SOLICITATION NUMBER: DEFK13008**Addendum Number: 1**

RFQ# DEFK13008
ADDENDUM No. 1

**Clarksburg National Guard Armory
#5 Armory Drive
Clarksburg, WV 26301**

ALL LABOR, MATERIALS, EQUIPMENT, AND SUPPLIES NECESSARY TO REPLACE ROOF AT
WEST VIRGINIA NATIONAL GUARD ARMORY
CLARKSBURG, WV

WV National Guard Armory

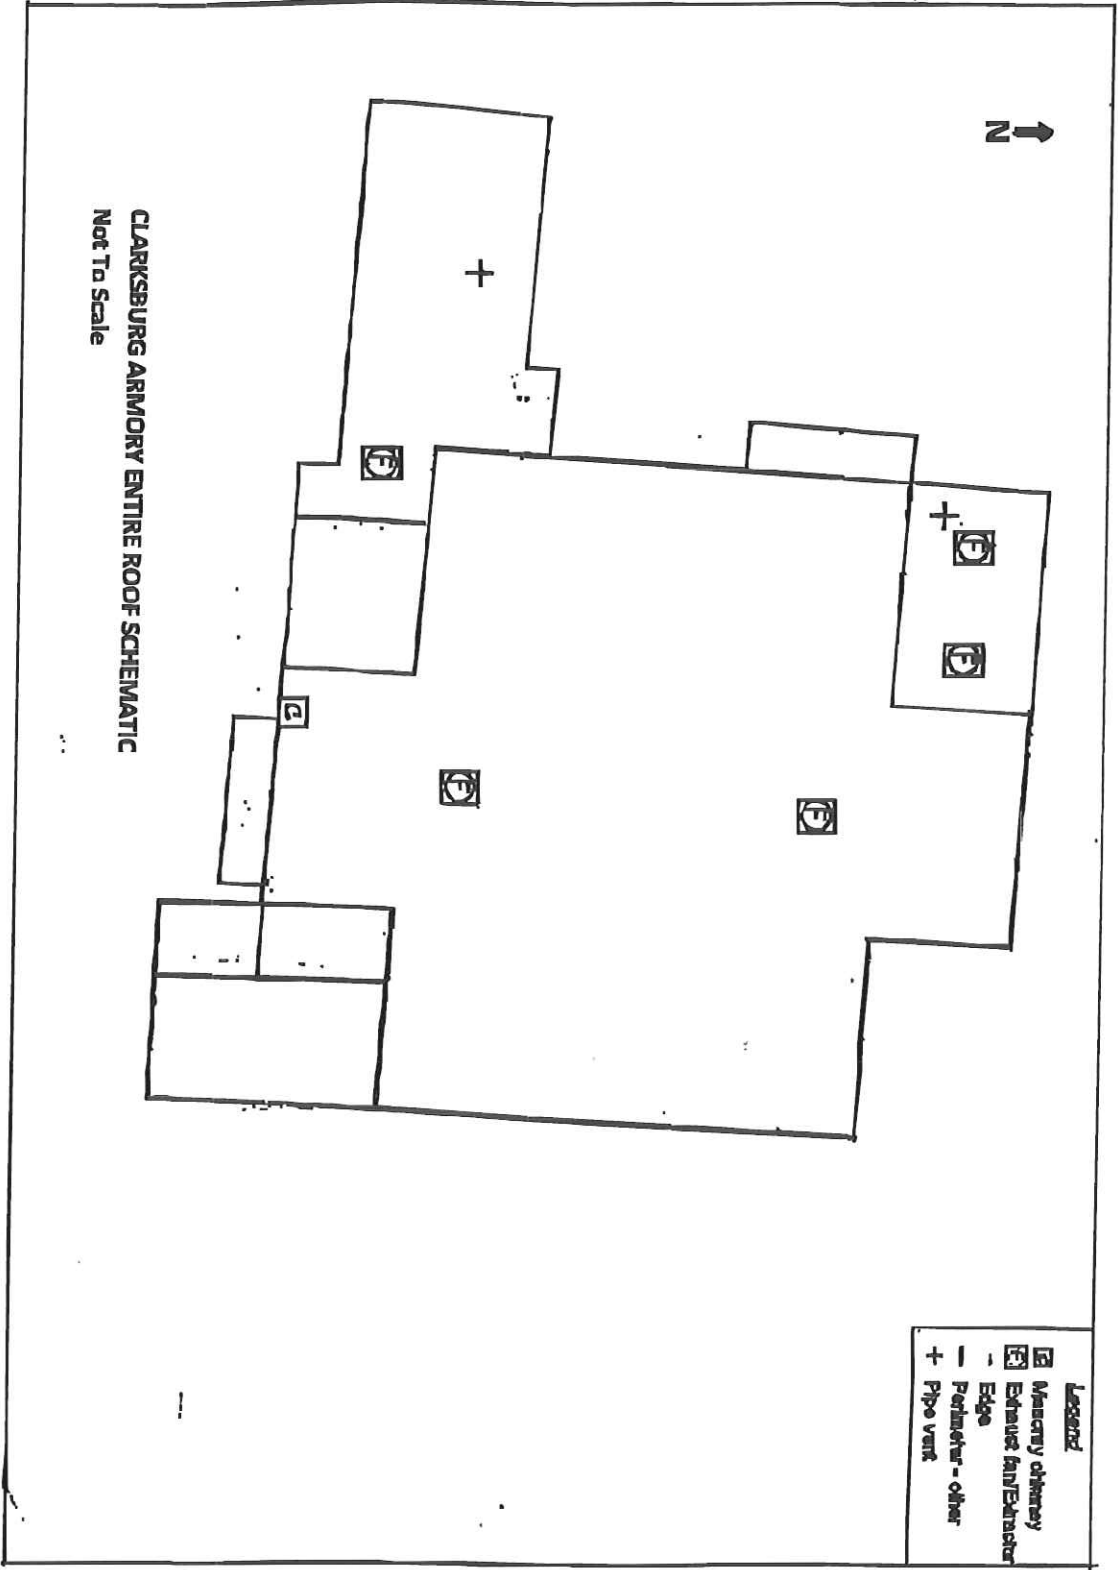
Q. Is roof insulation to be flat over the drill hall? Will it be installed in two (2) layers or one (1)? Will it remain 3-1/2" overall thickness?

Q. Is the roof insulation on the lower levels to be tapered? If so, what is the desired minimum thickness and slope?

Q. Is the roof deck over the drill hall to be replaced? If so, what thickness of Tectum decking is required?

Q. Is the existing roofing ballast to be disposed of onsite or off site?

A. Roof insulation is flat over the Drill Hall. Insulation is to be installed in one layer of 2" and one layer of 1-1/2" for a total of 3-1/2" thickness. (R-Value of 21.1)

A. Insulation on the lower levels will be tapered with a 3" minimum thickness sloped at 1/8" per foot. Structured sloped metal decks at the two stair towers shall be 3-1/2" thickness installed in two layers.

A. The entire Tectum roof deck in the drill hall is to be replaced under this contract. The thickness is 3".

A. The ballast may be disposed of in the motor pool area on site.
